CHANGE ORDER NO.: 6

| Project: | WWTP Improvement Project | | |

Town of Bristol
WWTP Improvements Project
Change Order #6

**RE: Job Number S22145
 WWTP Improvement Project
 Proposed Change Order No. 6**

Pictures showing existing Ferric Chloride room and existing pump system

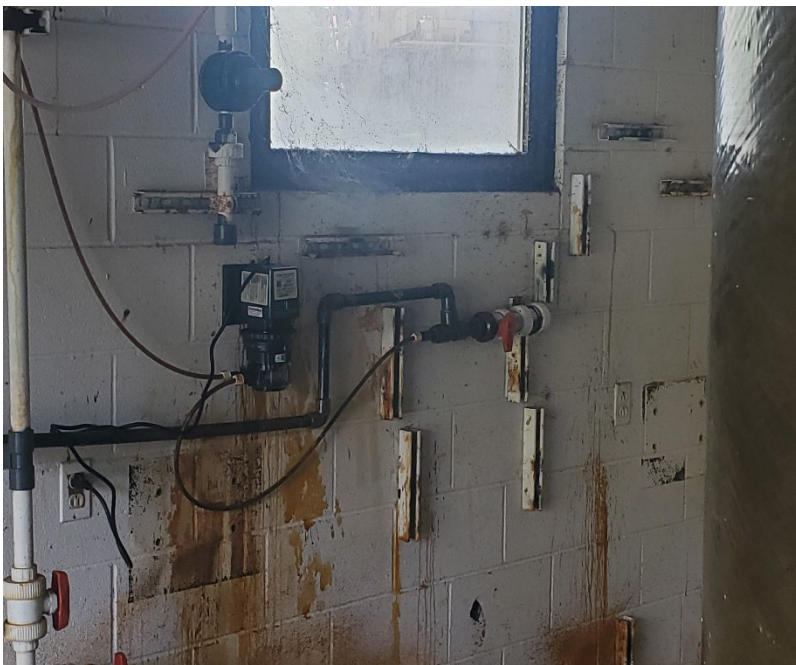
Part 8 of the Detailed Specifications, Section 00 General Requirements - 3.05 Sequencing sub section 9a States: **Existing chemical feed facilities to temporarily remain in service –temporary feed line(s) shall be routed to the new SBR process.**

Please provide clarification regarding the above statement.

It is not anticipated that the existing ferric chloride pump can be used to temporarily dose at the new SBR. Contractor shall check the lead time on the new chemical pumps to determine if they can be received prior to completion of Part 1 of Contract. Temporary chemical feed lines shall be set up between the existing chemical building and connected to Line PM-B temporarily. If this occurs during winter, the temporary line will either need to be buried or jacketed/heat traced. Contractor to submit proposed temporary line and tie-in method for Engineer review.

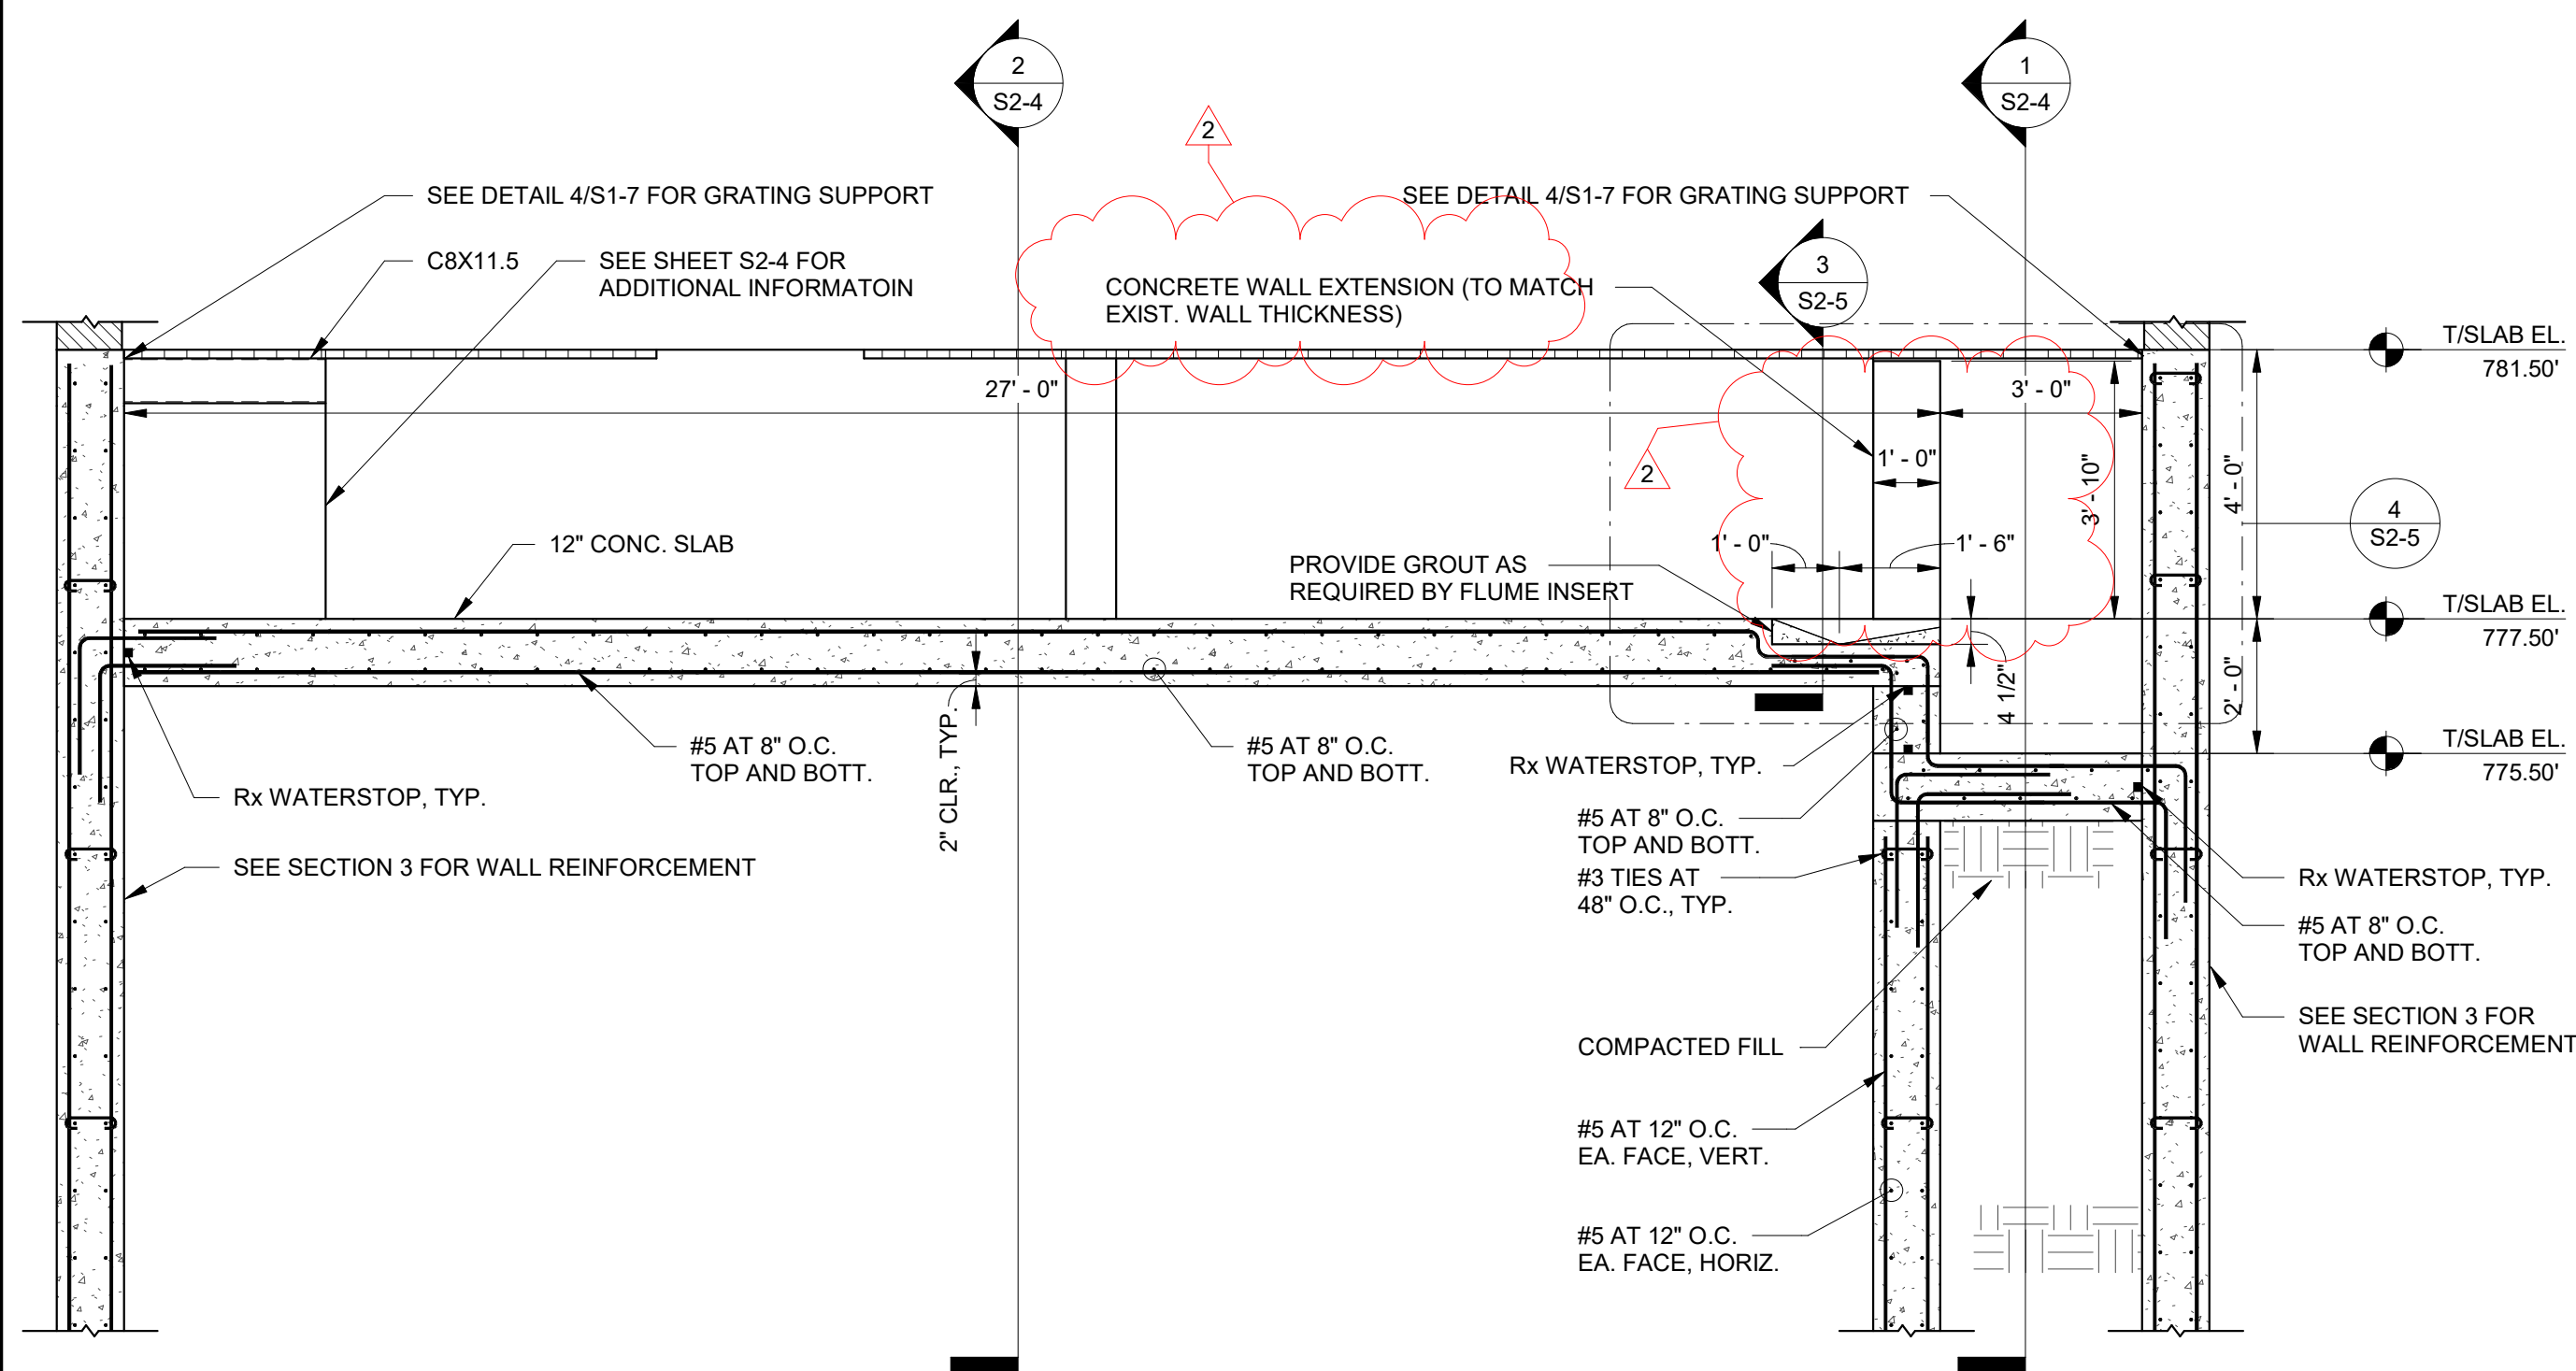
1. The channel wall separating the headworks screen channel and bypass channel was constructed 1 foot too short due to a discrepancy between the process and structural drawings on the length of the channel wall prior to the sump. The issue was noticed when the Contractor asked about installing the flume with one foot of the flume extending beyond the end of the channel wall.
2. The channel separation wall is necessary to separate the channels prior to the sump.

1. The channel wall shall be extended by 1 foot following the attached revised plan sheet S2-5.
2. The flume shall be installed against the extended wall.
